Sub: Diversion of 42.46625 ha Protected Forest land for the project of widening & strengthening four lane of Mitha Tharad Deesa Road (Section Deesa-Lakhani road) Ch. 56/340 to 88/390 Ta. Deesa & Lakhani, District Banaskantha in favour of Executive Engineer, R&B Division, Palanpur, Gujarat.

43rd Meeting of Regional Empowered Committee, Bhopal
Dt. 25/02/2020

Agenda No. 14

✓ Diversion of 42.46625 ha Protected Forest land for the project of Widening & Strengthening four lane of Mitha Tharad Deesa Road (Section Deesa-Lakhani road) Ch. 56/340 to 88/390Ta. Deesa & Lakhni, District Banaskantha in favour of Executive Engineer, R&B Division, Palanpur, Gujarat (6-GJA01/2020-BHO)

DSS Analysis:

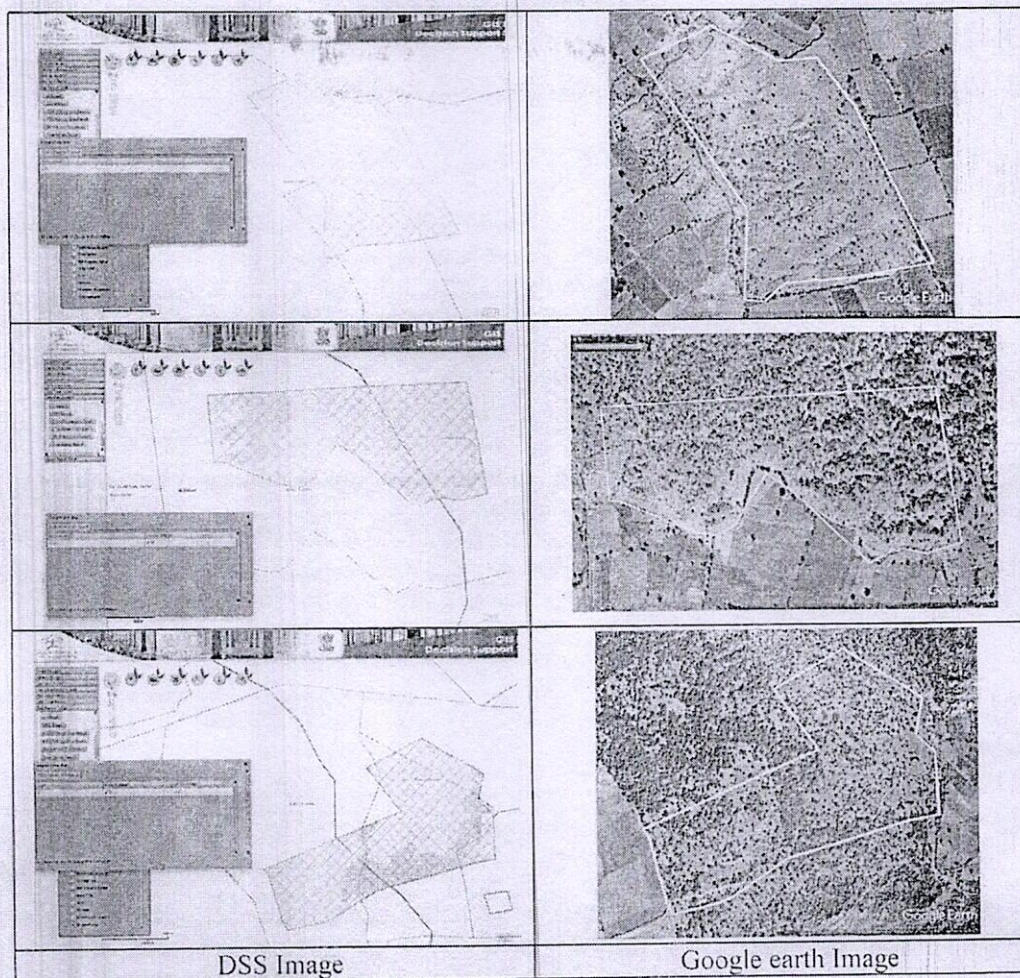
- 1) The widening of road is proposed 42.46625 ha and KML file is submitted for 73.70 ha. The length of KML 32.00 ha which is, correct as per requirement, however, due to width the variation in area of KML file is observed.
- 2) As per DSS CA area of 50.30 ha shows MDF in 11.00 ha.
- 3) The CA scheme is not in accordance to para 2.8(iii) of FCA handbook, 2019. The CA scheme is proposed for 858 plant per ha.

Proposed land = 42.46625 ha	DSS area= 36.85+63.85 =73.7 ha

DSS Image	Google earth Image
Proposed CA land =10+25+50 = 85 ha	DSS area=10.03+25.37+50.30=85.7ha - CA : 50.30 ha shows MDF in 11.00 ha.

1. The widening of road is proposed 42.46625 ha and KML file is submitted for 73.70 ha. The length of KML 32.00 ha which is, correct as per requirement, however, due to width the variation in area of KML file is observed. Thus, correct KM file of the proposed road of 42.46625 ha excluding blacktop road.
3. The revised site specific CA scheme shall be submitted as per the Para 2.8 (iii) of FCA Handbook 2019 and shall include the following points also:
 - a) Standard size Saplings to be planted (Minimum standard height and minimum collar girth species wise) as approved by the State Govt.
